Implementation of PRIME Models and Data in Downstream  
Methods, NEDO-33173, Supplement 4-A, Revision 1,  
November 2012

**IMPLEMENTATION OF PRIME MODELS AND DATA  
IN DOWNSTREAM METHODS**

SUBJECT: NRC AUDIT OF GE-HITACHI NUCLEAR ENERGY AMERICAS TOPICAL REPORT NEDO-33173, SUPPLEMENT 4-A, "IMPLEMENTATION OF PRIME MODELS AND DATA IN DOWNSTREAM METHODS" (TAC NO. ME9033)

SUBJECT: FINAL SAFETY EVALUATION FOR GE HITACHI NUCLEAR ENERGY  
AMERICAS TOPICAL REPORT NEDO-33173, SUPPLEMENT 4,  
"IMPLEMENTATION OF PRIME MODELS AND DATA IN DOWNSTREAM  
METHODS" (TAC NO. ME1704)

Figure 1: ECCS/LOCA Evaluation Model Process Diagram (Reference 8)

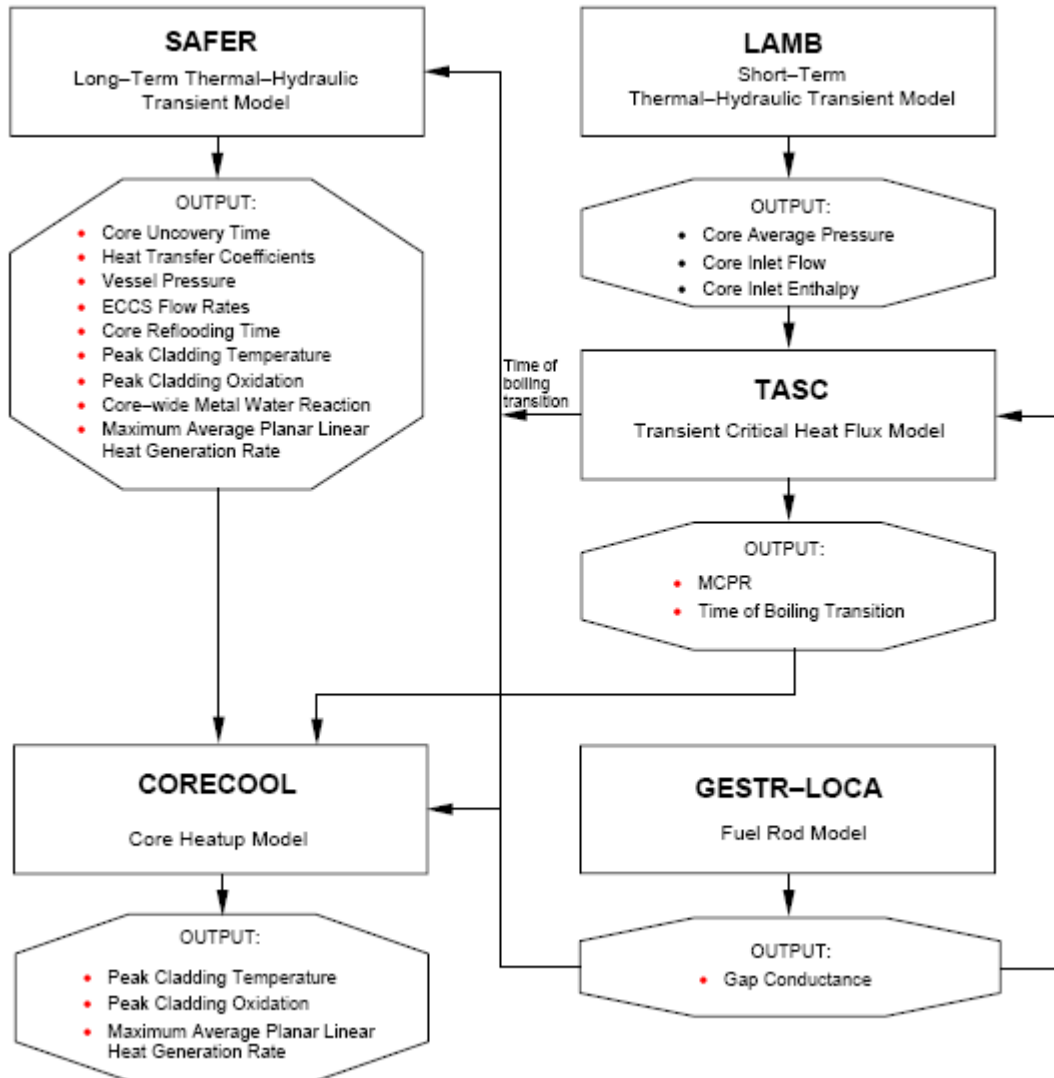
The basis for the Appendix K ECCS/LOCA evaluation model is SAFER/GESTR (Reference 1). The purpose of the SAFER code is to calculate long-term reactor vessel inventory and PCT for LOCA and loss of inventory events. SAFER is intended for use with GSTRM to perform ECCS/LOCA analyses. The various individual codes utilized in the ECCS/LOCA evaluation model are depicted in Figure 1. The GESTR-LOCA fuel rod model mentioned in Figure 1 is equivalent to GSTRM.

Supplement 4 describes one update to the SAFER model. The code will be modified to include an option to select the PRIME-based fuel thermal conductivity model as a function of temperature, exposure, gadolinia concentration, additive concentration, and fraction of theoretical density. Inputs to the SAFER code may provide a full description of the fuel initial conditions and are therefore sufficient to drive the PRIME-based model in the ECCS/LOCA calculations. The NRC staff finds this acceptable.
